# UNITED STATES PATENT AND TRADEMARK OFFICE

APPLICATION NO.	FILING DATE	FIRST NAMED INVENTOR	ATTORNEY DOCKET NO.	CONFIRMATION NO.
09/576,094	05/22/2000	Miles A. Galin	A31632-A	2498
23506	7590	05/10/2005	EXAMINER	
GARDNER GROFF, P.C. 2018 POWERS FERRY ROAD SUITE 800 ATLANTA, GA 30339			CHATTOPADHYAY, URMI	
			ART UNIT	PAPER NUMBER
			3738

## Office Action Summary

## **DETAILED ACTION**

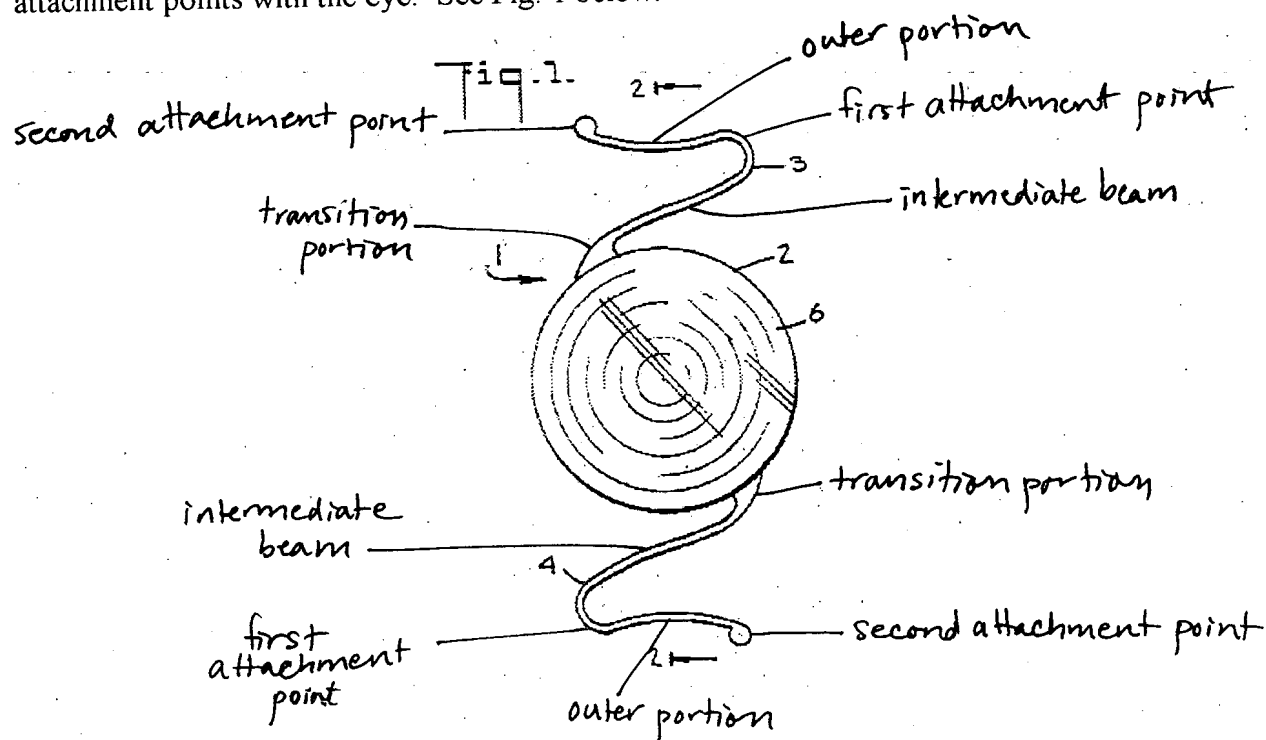
portion, and a second attachment point at a distal end of the outer portion, as recited in independent claims 21 and 33, or two haptics providing a four-point attachment, as recited in claim 1. The examiner disagrees. Absent any further structural and/or functional limitations to further define the first and second attachment points, Kelman does indeed disclose first and second attachment points as claimed, and two haptics providing a four-point attachment. When the IOL is inserted into the eye, the first and second attachment points of each haptic are the attachment points with the eye. See Fig. 1 below.
